Re: Initial Submission Review: Havana Shoppette – Site Plan Amendment
Case Number: 1971-6002-03

TMG RESPONSE TO CITY COMMENTS

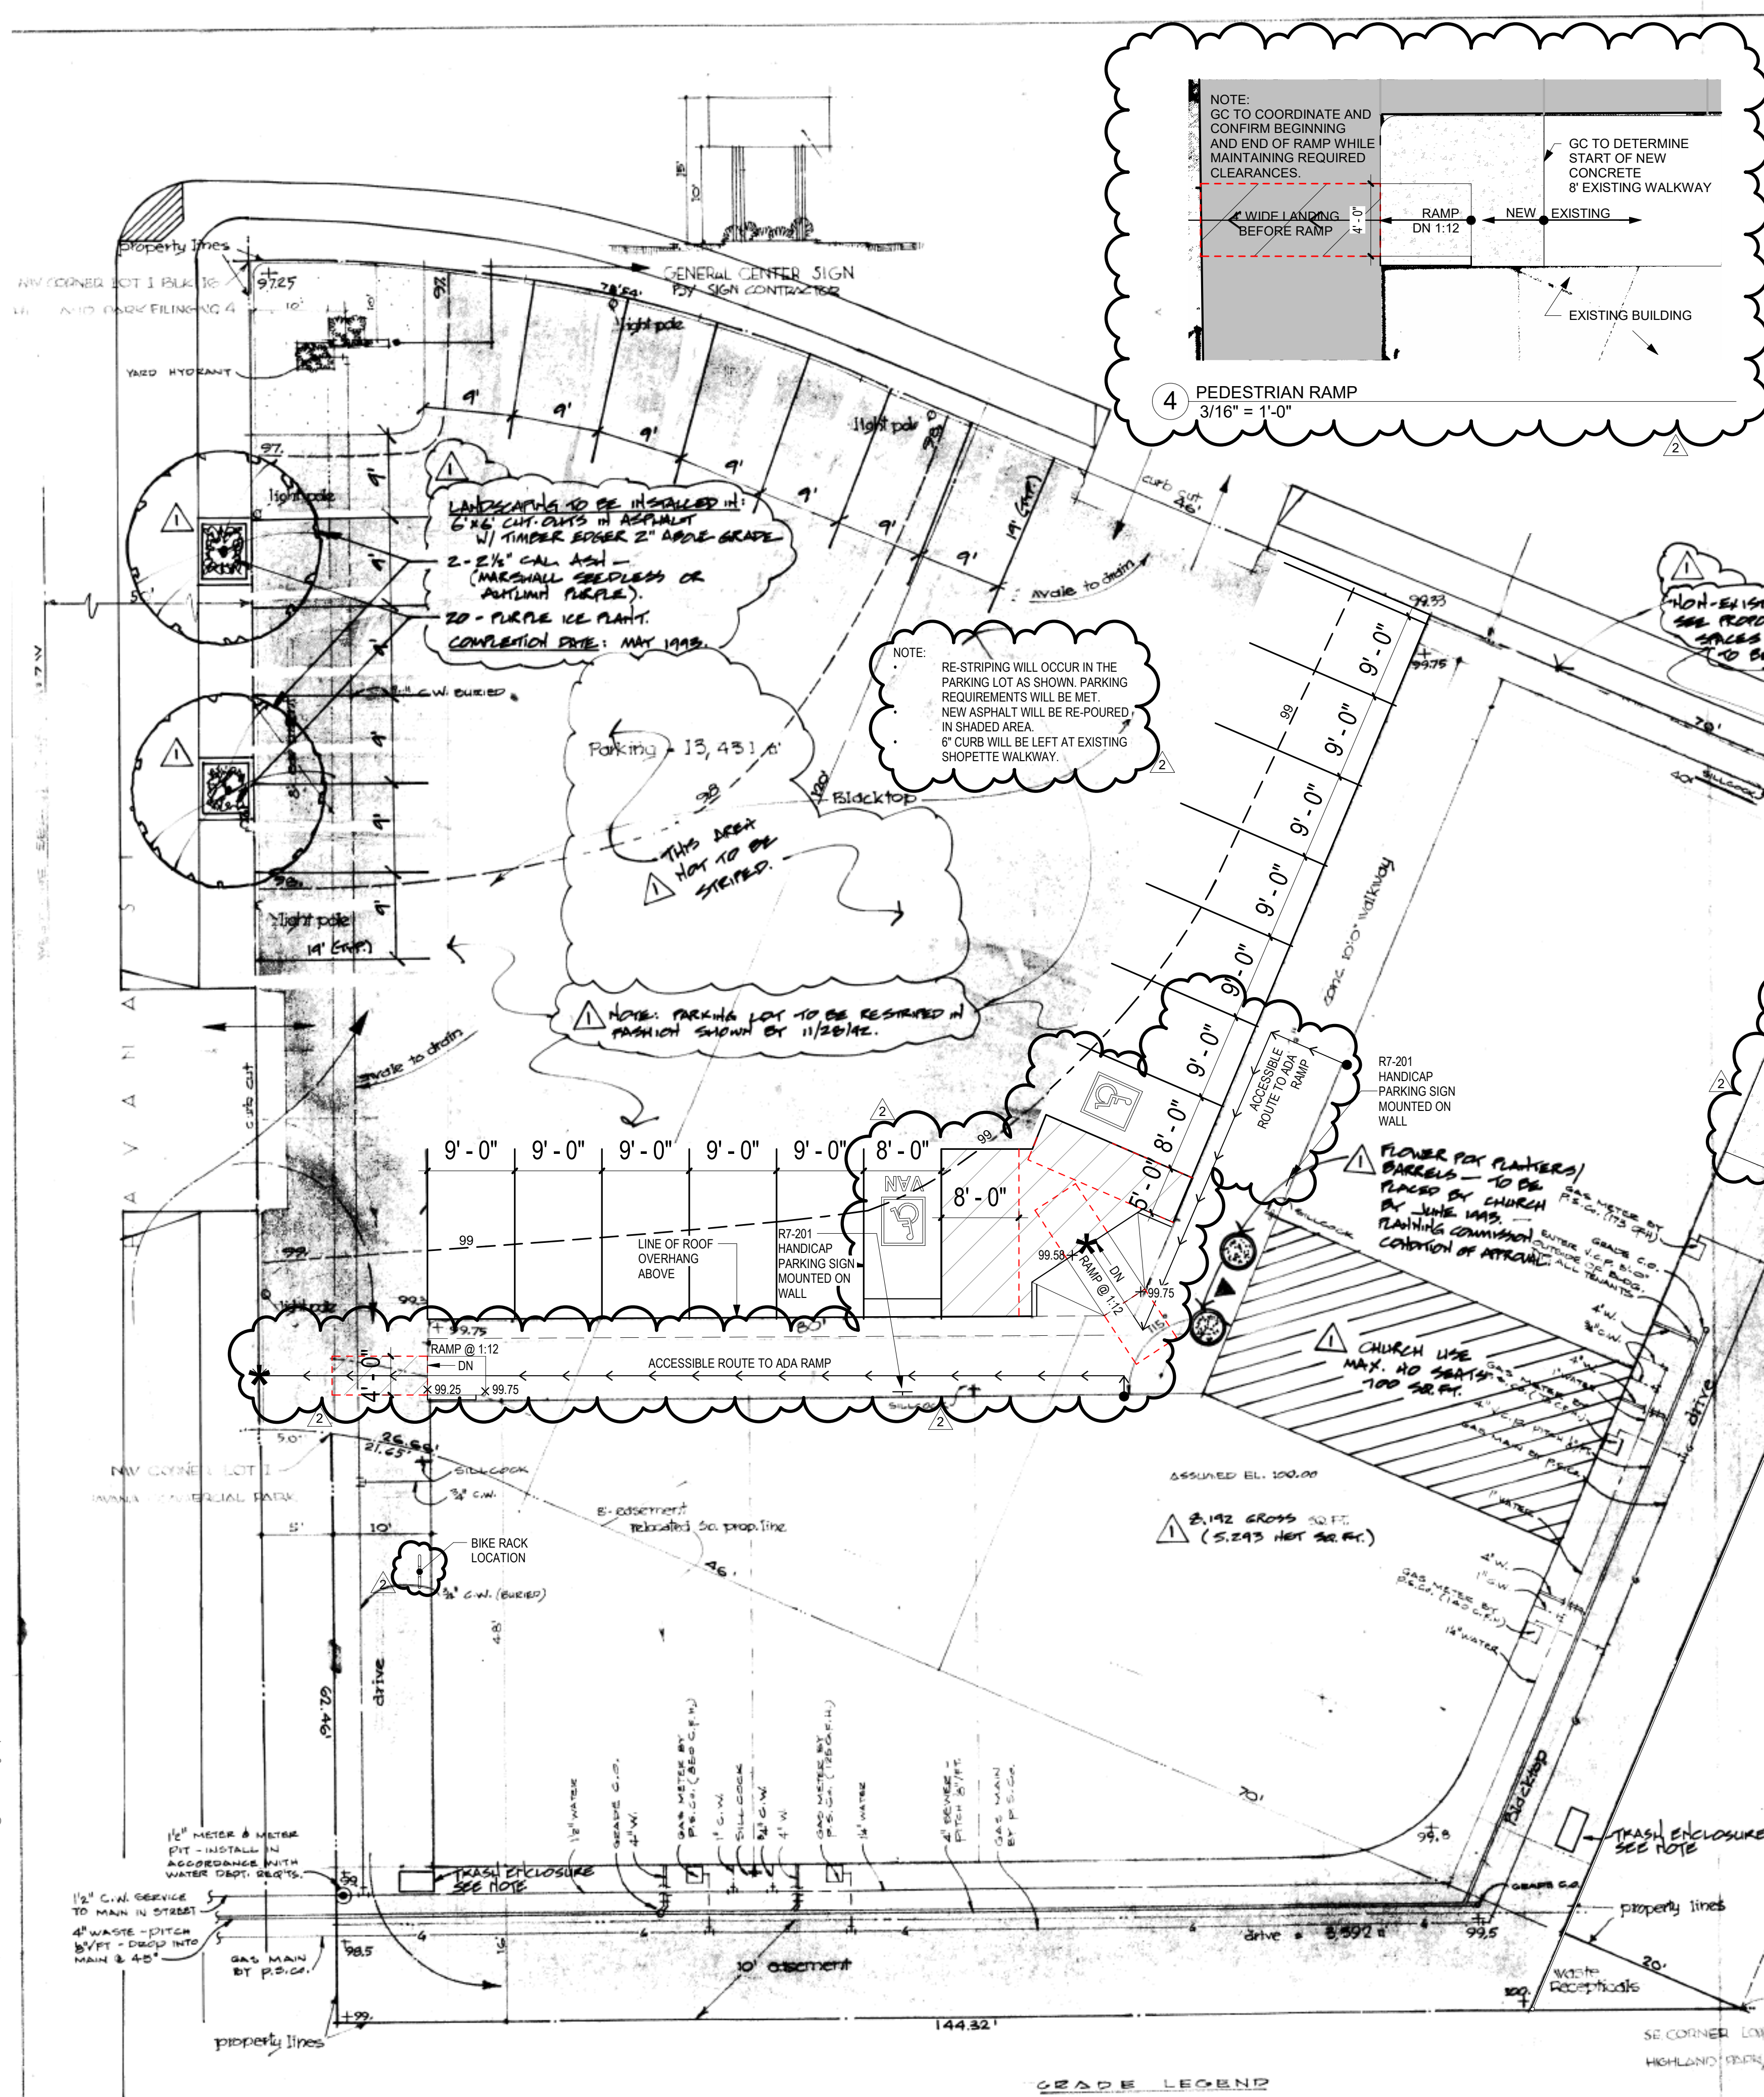
- Please add a cloud and delta “2” for any new addition to the site plan as shown on the redlines.
[Response: Cloud and Delta 2 has been added to all new drawings and notes added to the existing Site Plan](#)

- A civil plan is required to provide the detailed grading and layout for the proposed ADA spaces and slopes. The civil plan shall be submitted prior to the approval of the site plan amendment.
[Response: Civil plans showing grading at the ADA parking stalls are in progress. We have resubmitted to get comments from other reviewers.](#)
- A letter from an engineer is not adequate. A stamped civil drawing is required to prove compliant ADA grades in the City of Aurora. Please contact me directly for any further questions regarding this process: jbingham@auroragov.org
[Response: Acknowledged, we are proceeding based on your comments and email correspondence between Civil Reviewer and Ricardo Castellanos.](#)

- Repeat request to show any accessible routes in the areas being amended. The City of Aurora uses the 2017 ICC A117.1 Accessible and Usable Buildings and Facilities as the standard. Please see Chapter 4 regarding accessible routes.
[Response: Accessible routes have been amended and annotated per notes sent via email correspondence with reviewer.](#)
[Accessible routes are shown in a format approved by reviewer and follow ANSI requirements.](#)

- Please show wheel stops and accessible parking signage. See example provided.
[Response: We are providing a 6” tall curb as well as 2’ that allow for a bumper overhang before providing a 6’ walkway that will serve as the accessible route and general entrance to the tenant spaces.](#)
[Please let us know if this is sufficient as to not need to provide wheel stops.](#)
[CS02 Accessible Signage will be located on the building wall directly across from the parking stalls and mounted according to ANSI 2017 standards in Sections 502.2 and 703.](#)
